## Annex 1

### COMPILATION OF PUBLIC COMMENTS ON DRAFT CONSOLIDATED TOOLS FOR THE DEMONSTRATION OF ADDITIONALITY

1. This document compiles 30 public comments received from 7 to 21 September 2004 on draft consolidated tools for the demonstration of additionality. The draft had been agreed by the Executive Board at its fifteenth meeting. The Board had further agreed that it will consider these comments with a view to agreeing on these tools at its sixteenth meeting. The detailed comments have been made available to the Executive Board and the public as of the 21 September 2004 on the UNFCCC CDM web site (please refer to: <http://cdm.unfccc.int/methodologies/inputadditionality/index.html>).

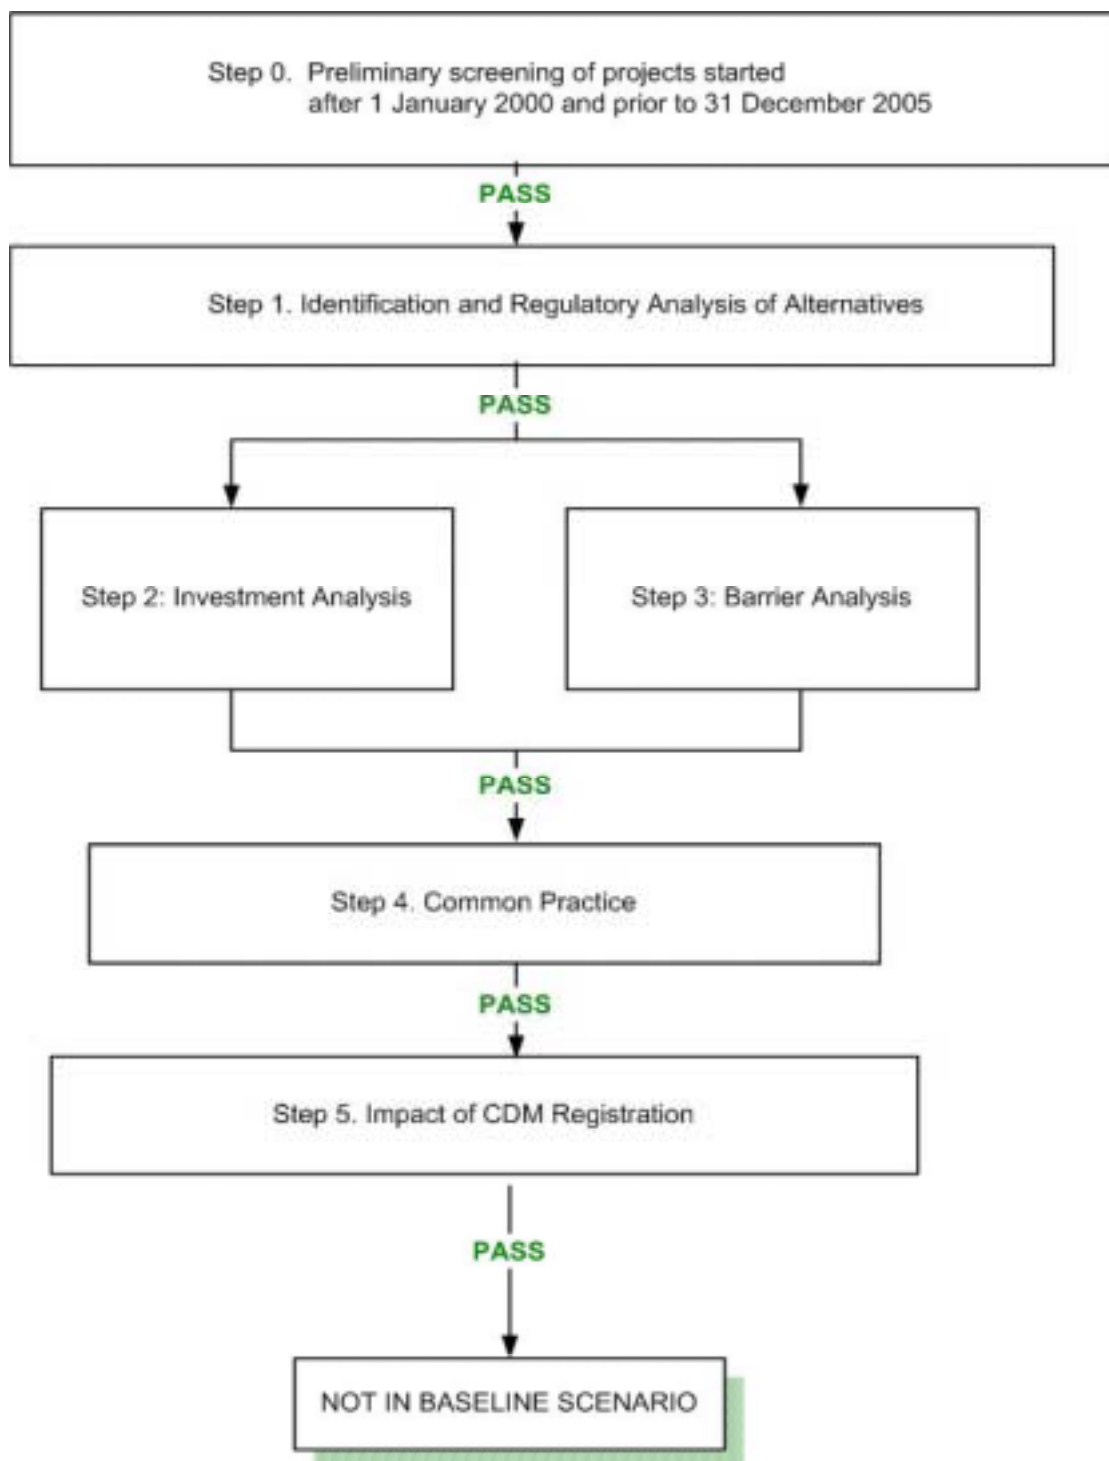
*The last box should be named “additional” and not “not in baseline scenario”, as the scheme is about determining additionality.*

*You should add a phrase that states under which condition a project activity is additional. E.g. “If steps 1 to 5 are passed...”, flowchart (1) may state in the end “project activity is additional”.*
